# PLANNING COMMISSION PACKET

November 1, 2016

MEETING AGENDA  
CITY OF MOUNTAIN BROOK  
PLANNING COMMISSION  
NOVEMBER 7, 2016

Additions and Renovations to St. Luke's Church (Planning Commission P-16-24)  
#166009-00

**SAINT LUKE'S EPISCOPAL CHURCH**  
**PROPOSED SITE DEVELOPMENT PLAN**  
**ATTACHMENT A**

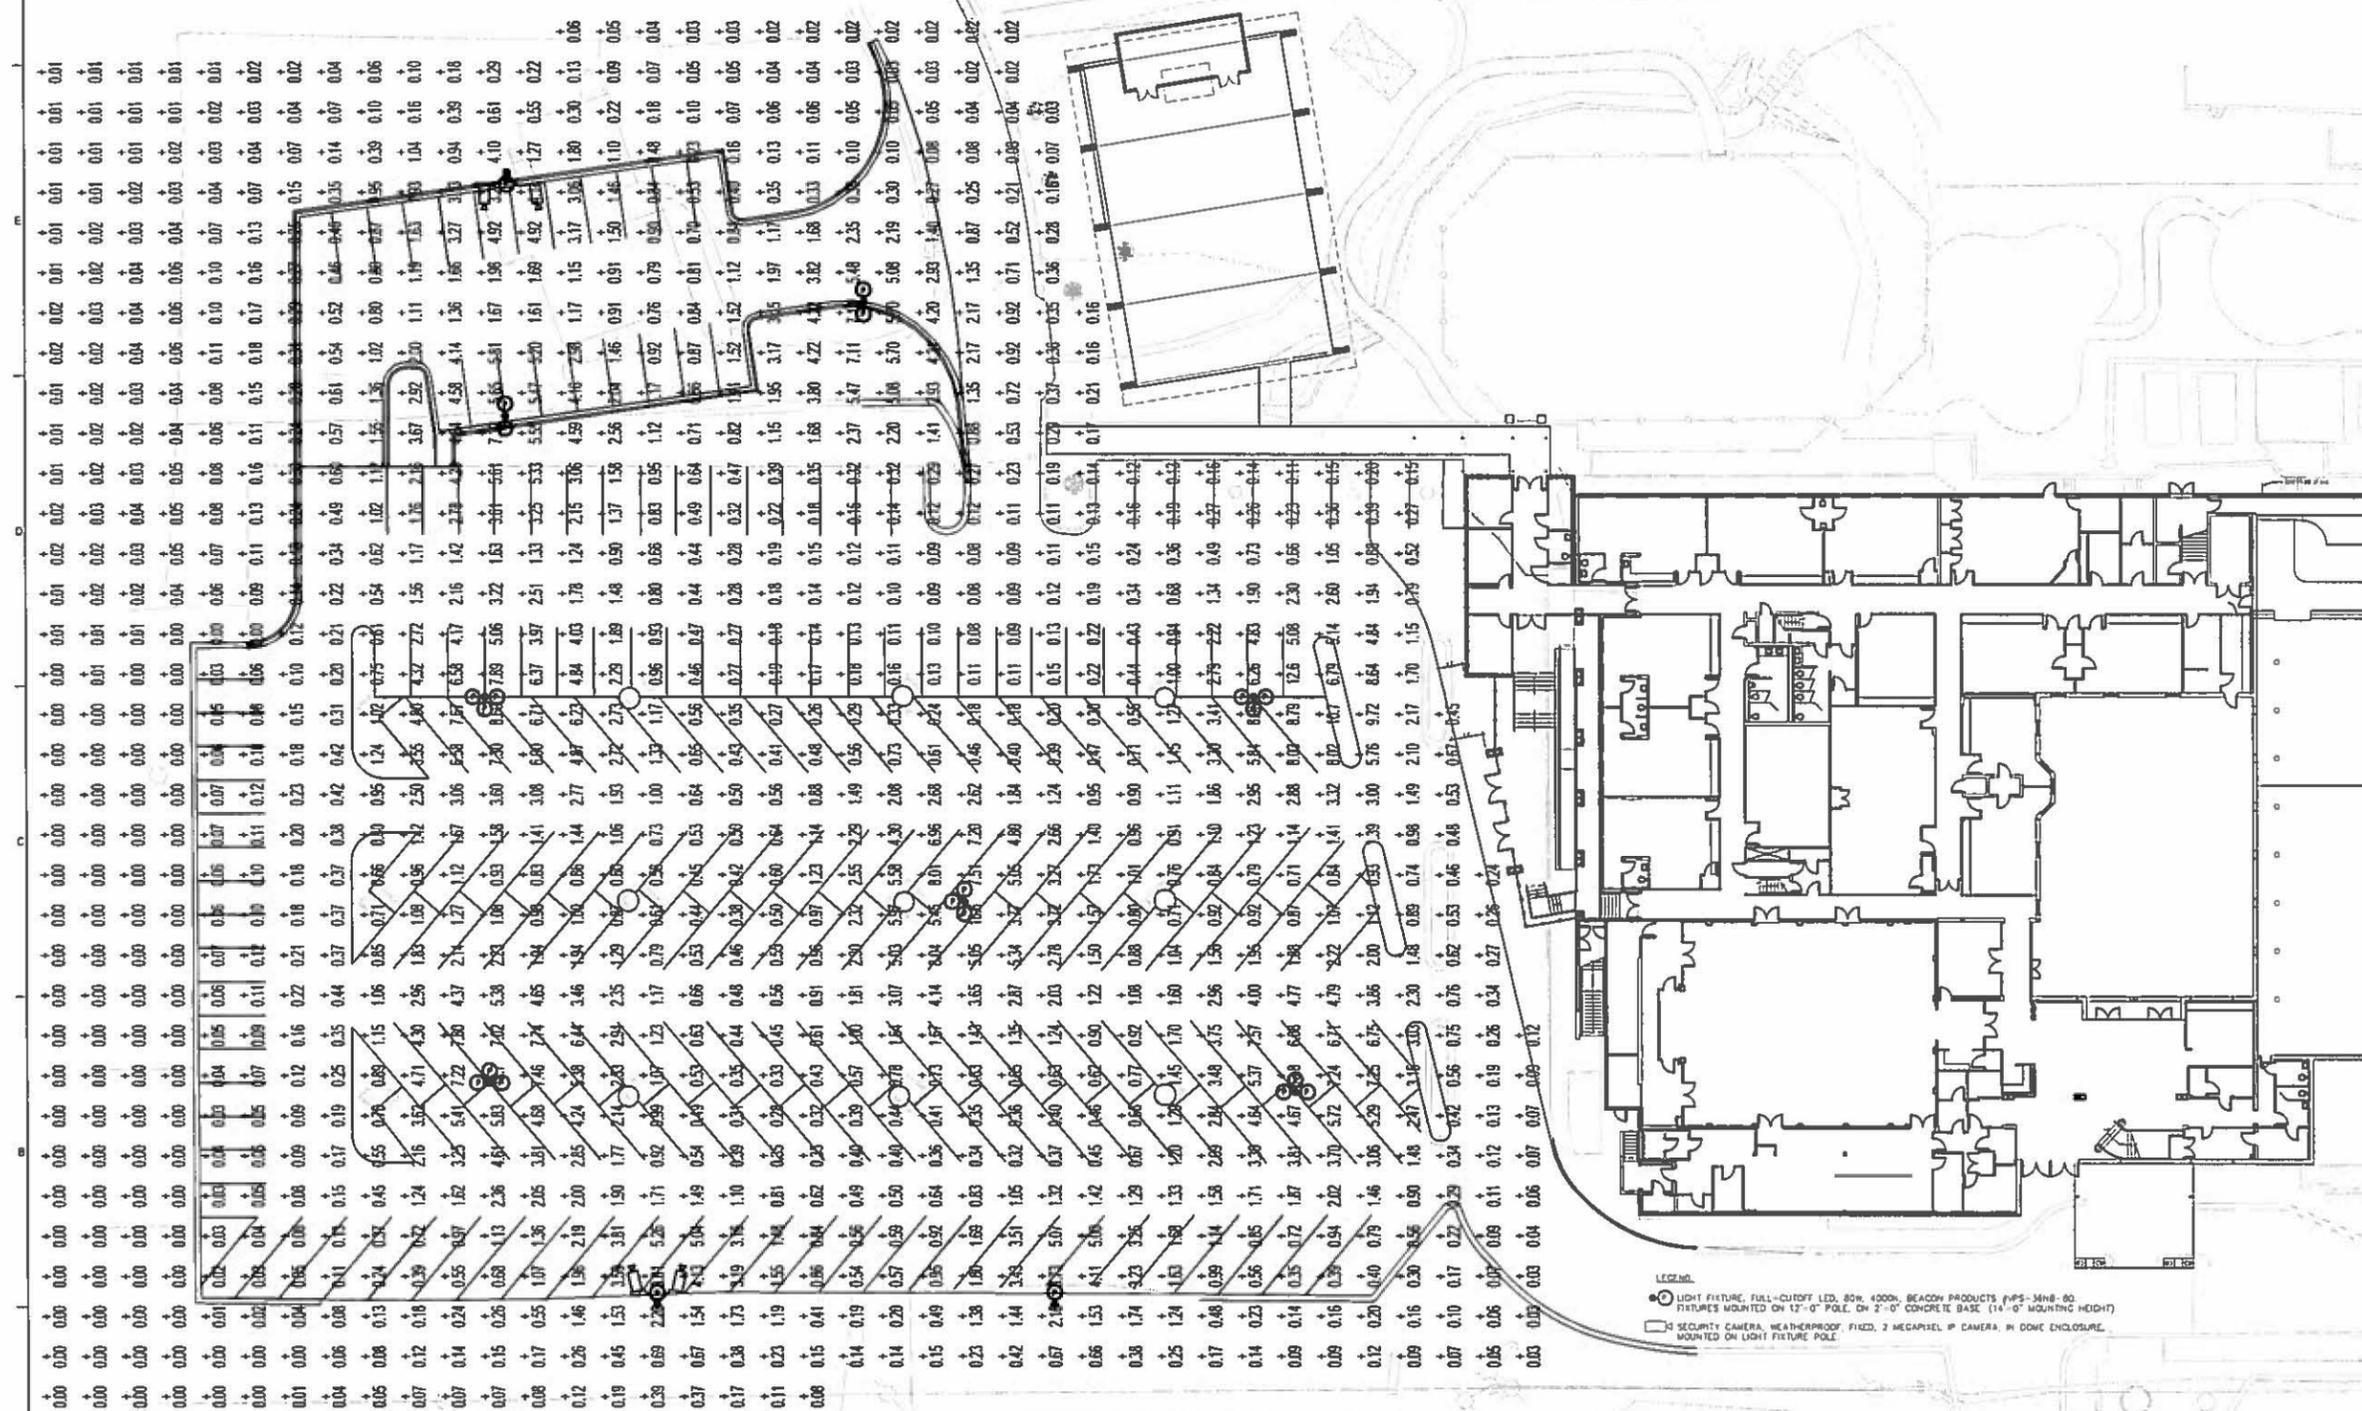
- Attachment A consists of the original development plan documents submitted for this case that have been revised to reflect all subsequent changes made in response to PC requests. These include changes in the size and position of the proposed new parking lot to incorporate the change in gate location, the new sewer easement, changes to the landscape buffer and a reduction in the overall number of spaces from 27 to 21. It also provides for a foot path to the house and repositions the pavilion slightly further away from South Cove. The number of new parking spaces has been changed as a result of the reduced size of the new parking lot. The height of the pavilion has been changed to 35 feet.

On October 3, 2016, the Planning Commission voted to carry over the subject case for more detail on the following items:

1. Parking mitigation in the turn-around area;
2. Pavilion height;
3. Gate usage;
4. Proposed uses for the residence;
5. Hours of operation for the pavilion.

This letter with attachments constitutes incorporates all previous changes to the original submission and the responses to all questions posed by the Planning Commission in its meetings of September 6 and October 3.

DRAWING TITLE  
**PARKING LOT PLANTING PLAN**

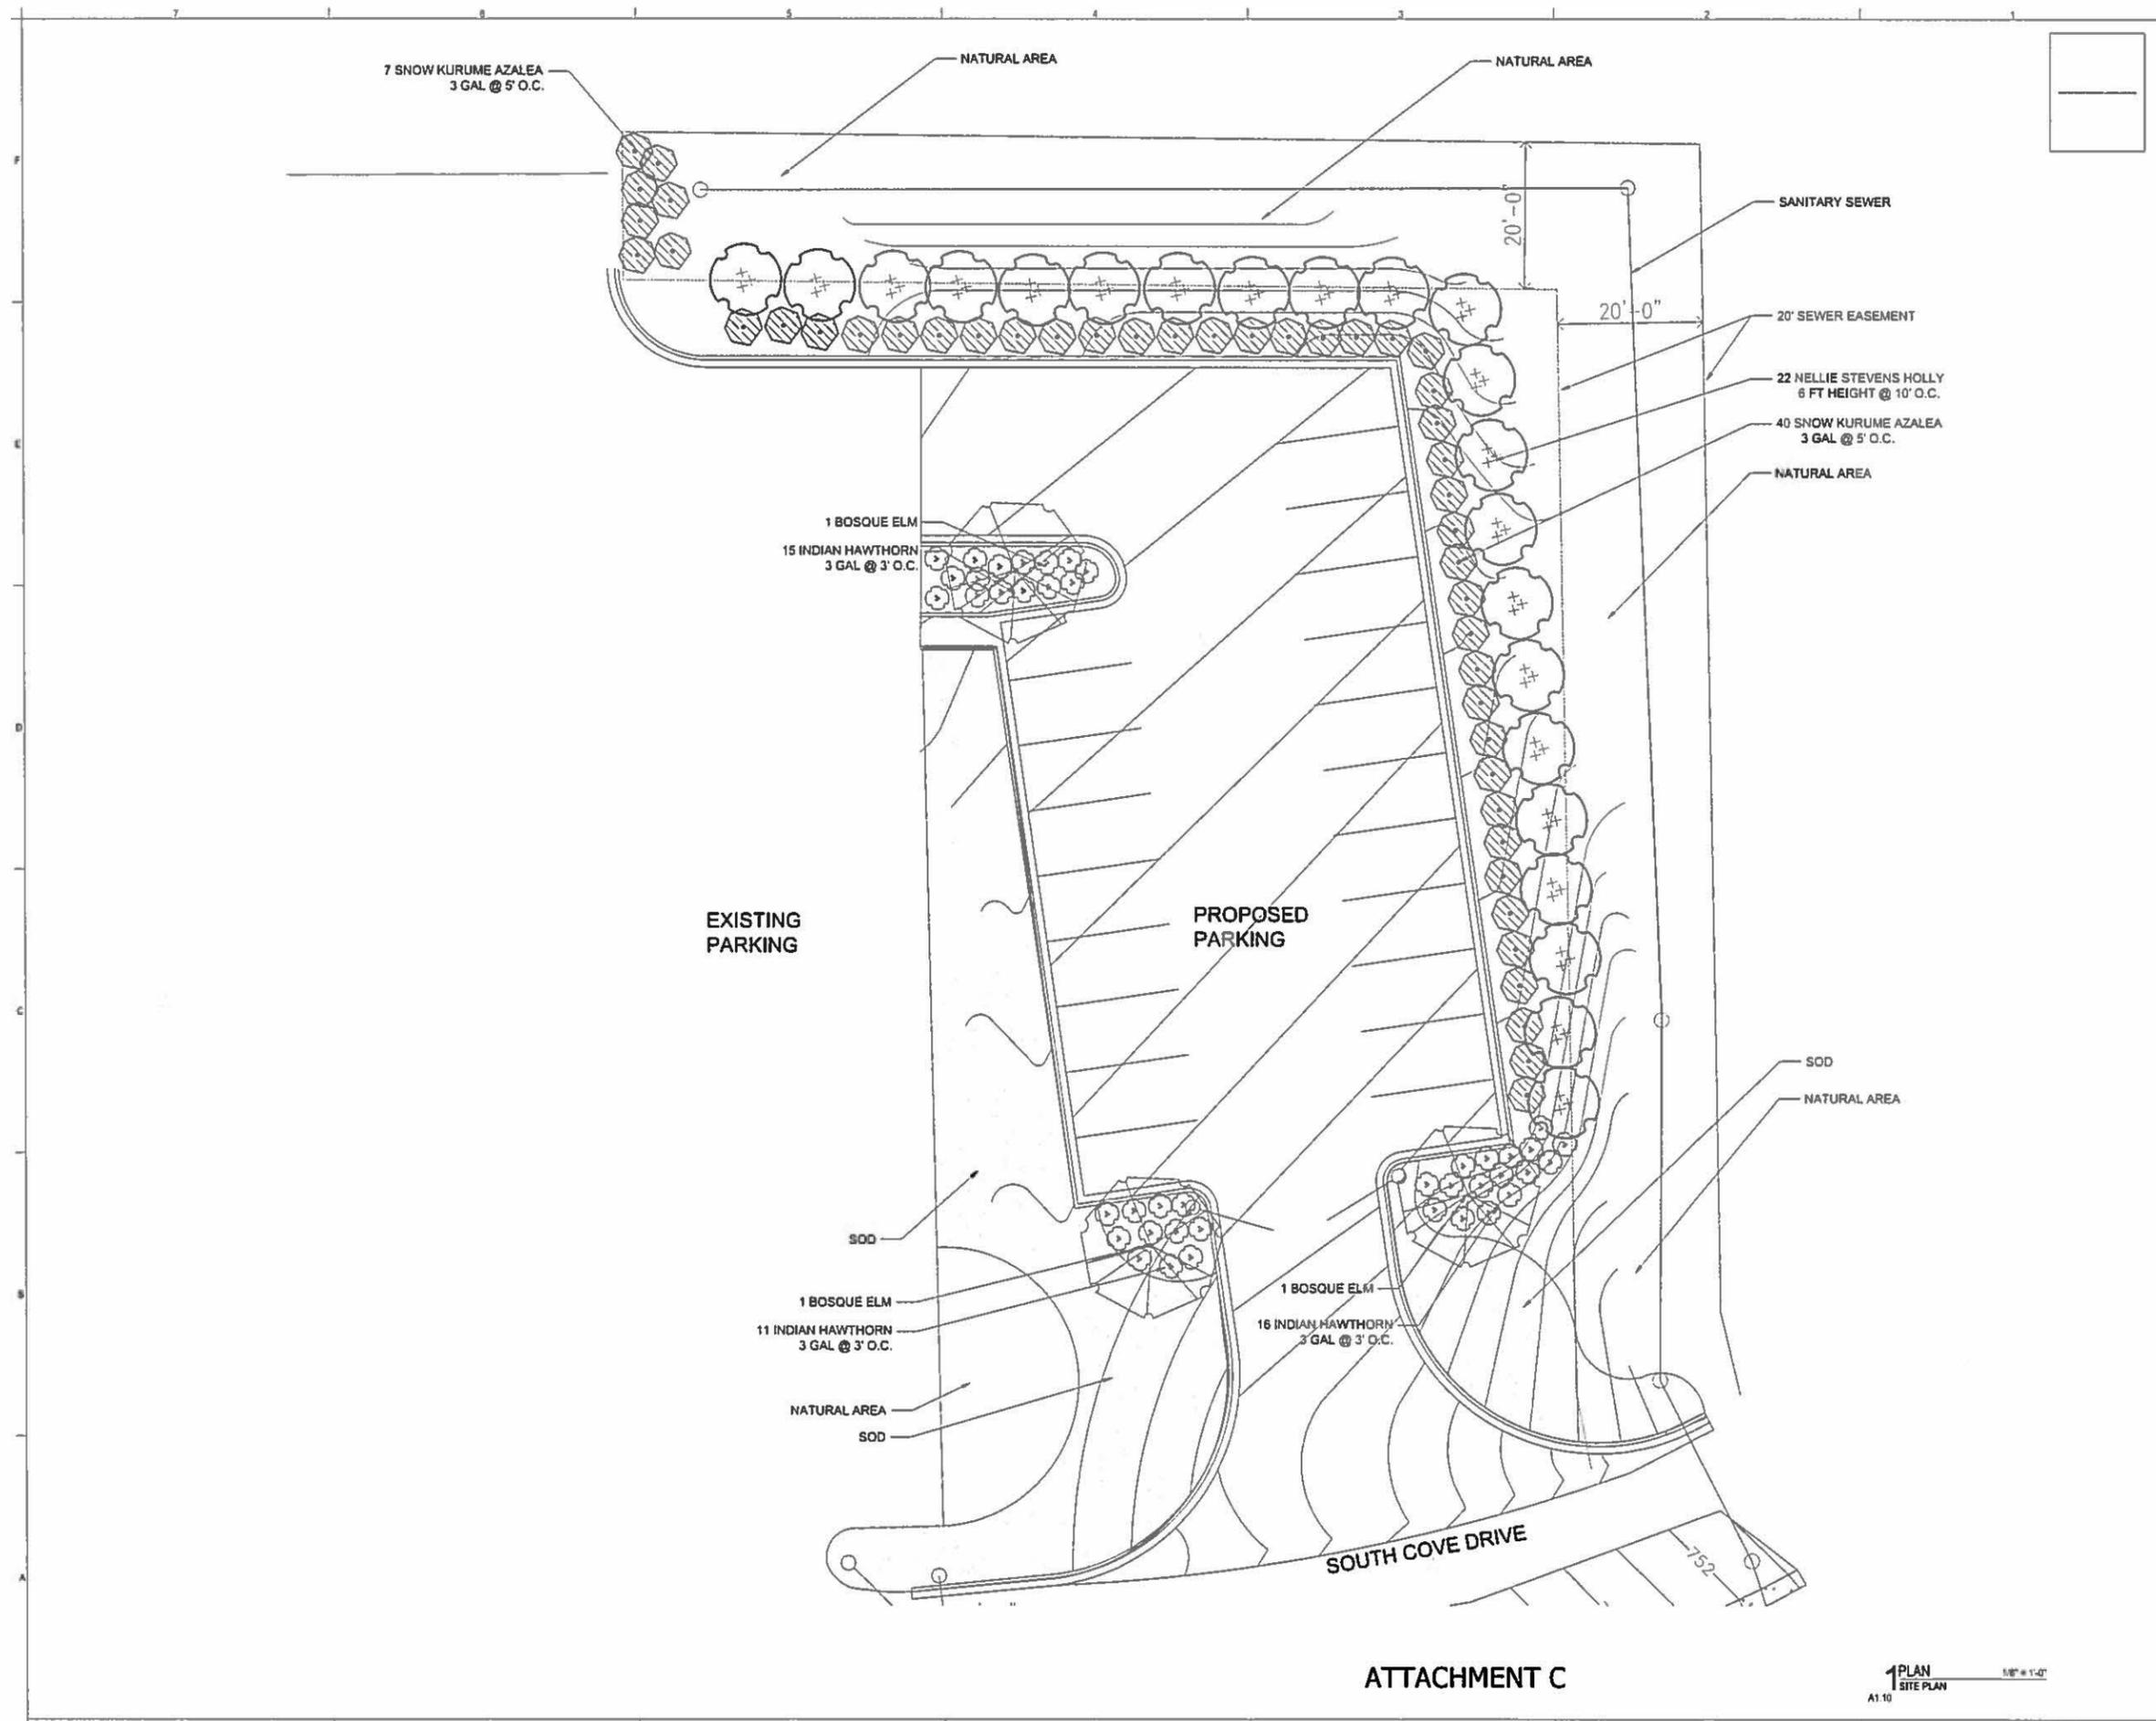
- *Schematic of the proposed landscape buffer – type of plants and location, especially in the sensitive areas along the east and north sides of the parking lot, as well as between the proposed pavilion and the south edge of the vacated South Cove Drive.*

The use of buffers for this project would help soften the visual effects of the institutional use on the residential neighborhood, specifically along the east property line of the new parking lot, and along the previous South Cove right-of-way line between the proposed pavilion and the pavement of South Cove.

Both of these locations contain existing, mature trees that should be left in place where possible, and it would be prudent to require shrubs to fill in along the base of these trees as well. Section 129-296 of the Zoning Code (attached) indicates

Response – See Attachment C consisting of two landscape drawings showing proposed schematic buffer landscaping of the new parking lot and another showing the proposed schematic landscape of the area around the proposed outdoor pavilion. Both of these drawings have been revised to reflect a) the reconfiguration of the new parking lot and b) the repositioning of the pavilion. The proposed plant material at the parking lot is now consistent with our original proposal for Nellie Stevens Hollies.

Sheet Title:  
**BASIN MAP  
PRE-DEVELOPMENT**

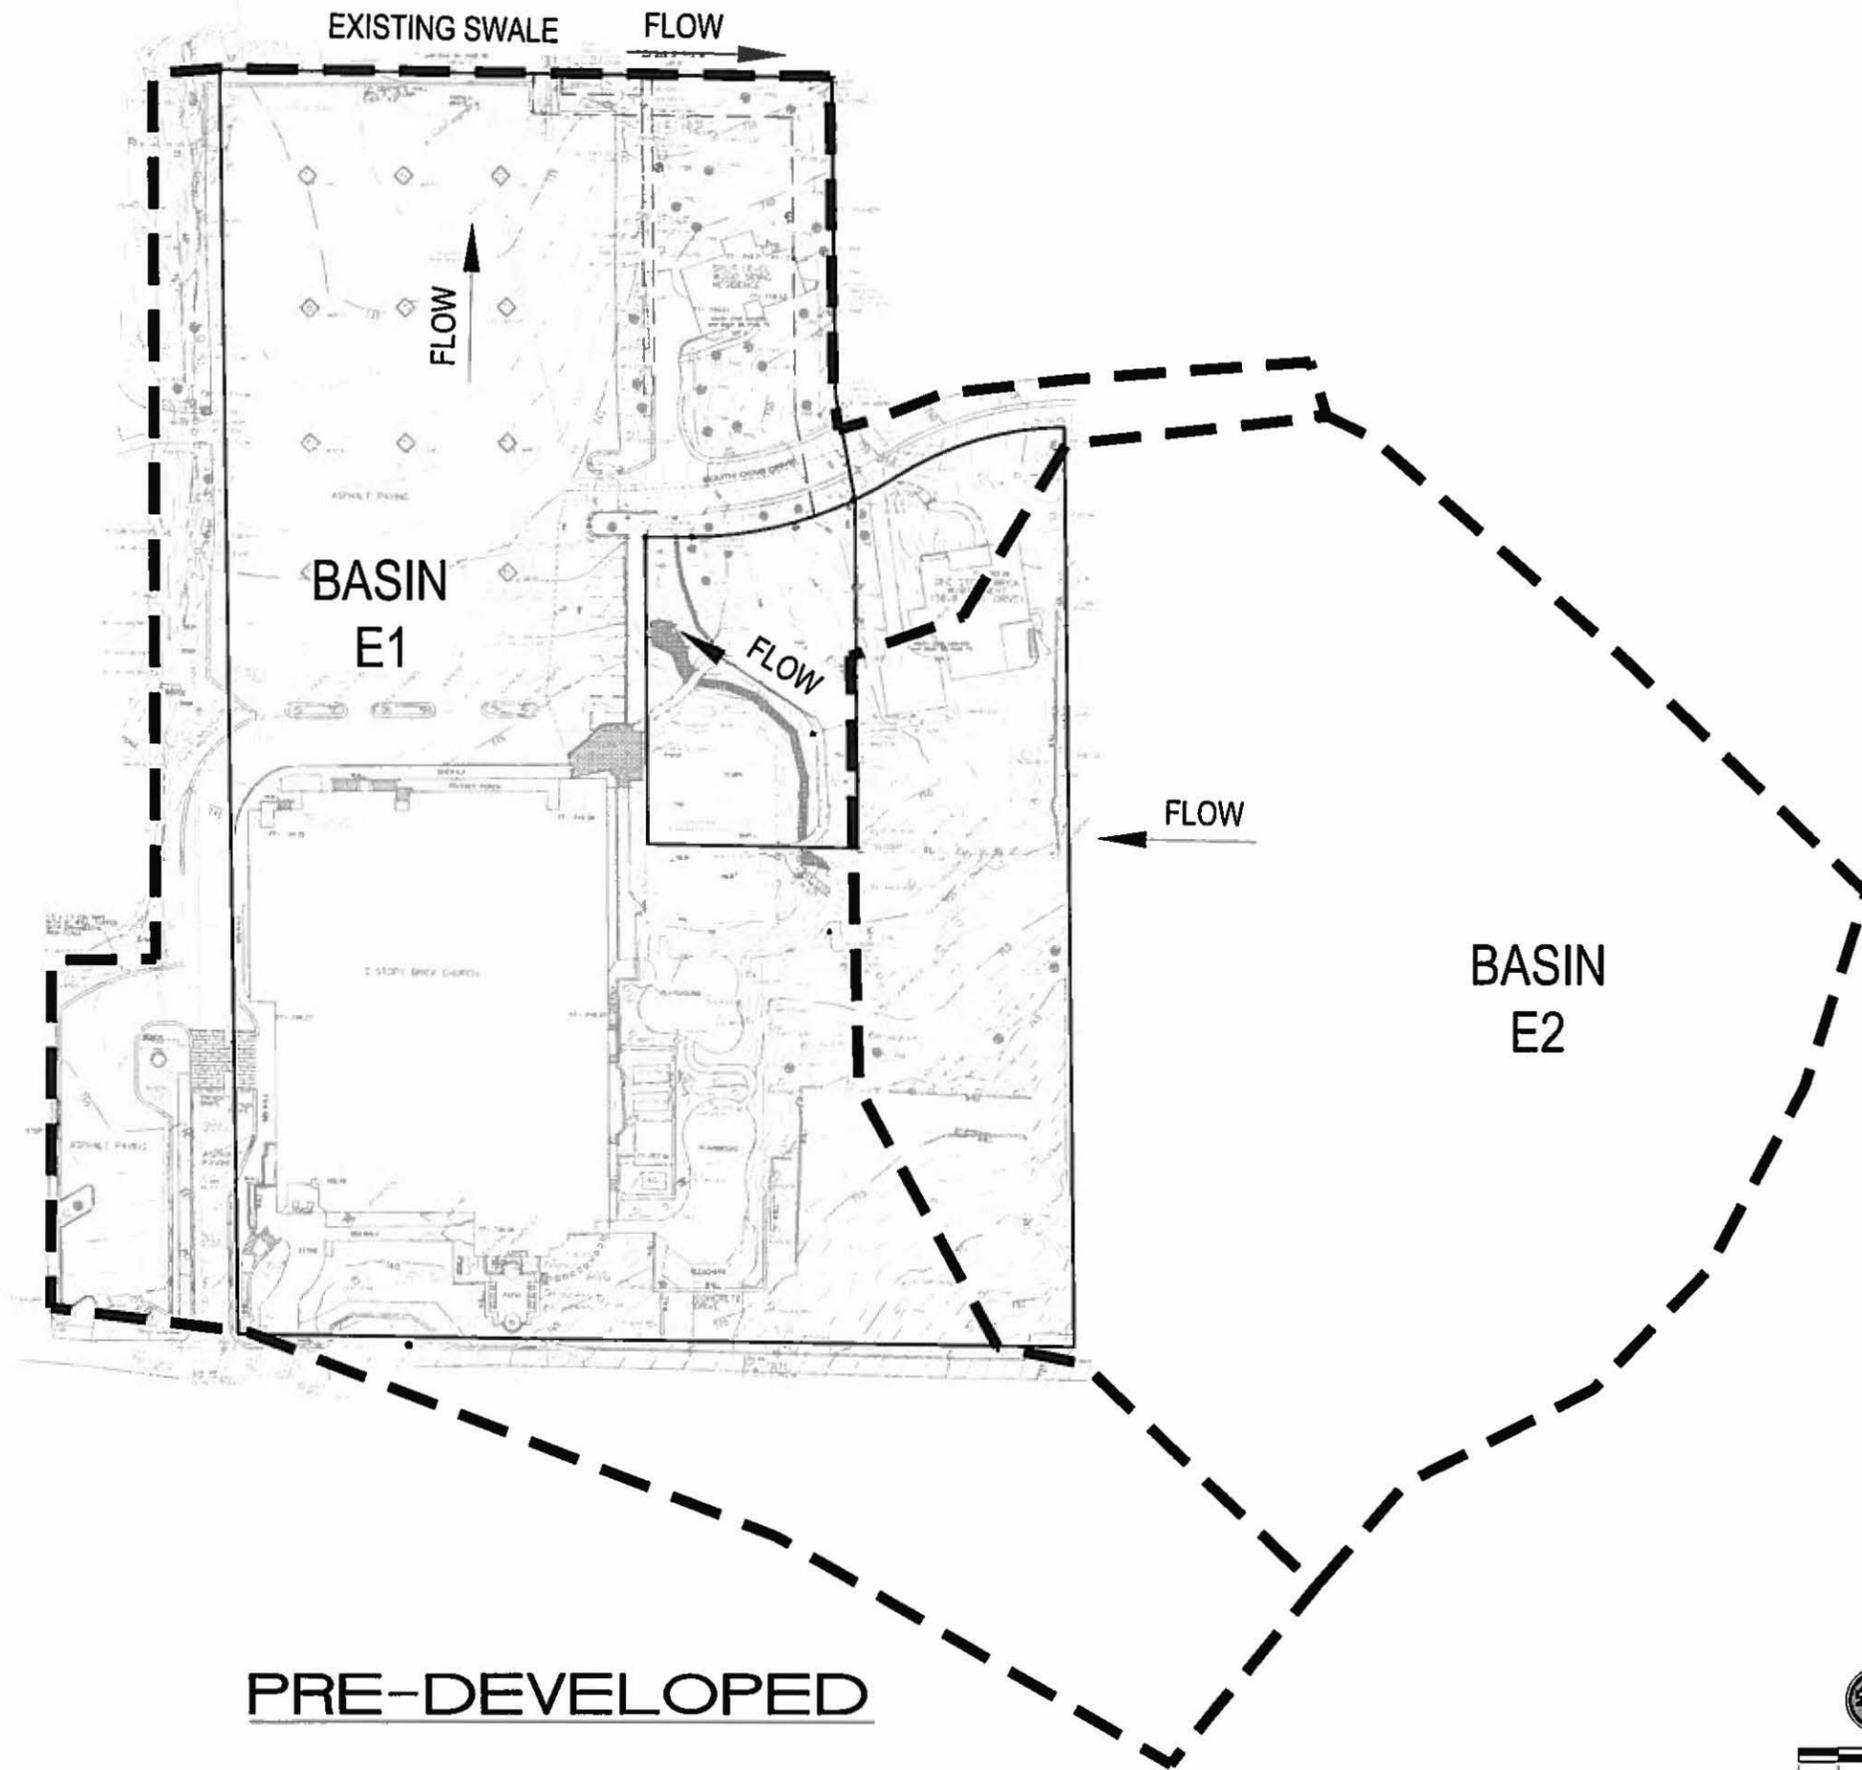
- *Analysis of drainage implications from the new parking lot.*

Response – See Attachment E consisting of a drawing and a narrative prepared by LBYD Consulting Engineers regarding the overall control of storm water on the site. The first drawing is of the new parking lot showing its location, size, preliminary grading and indicating how runoff will be handled. Essentially, storm water from this lot will be directed back on to the existing St. Luke’s parking lot and none across the property line to the north. Overall, the site will have a new detention facility located between South Cove and Montrose to insure that post development runoff is less than that predevelopment. The detention pond will have an outlet control structure to retain storm flows.
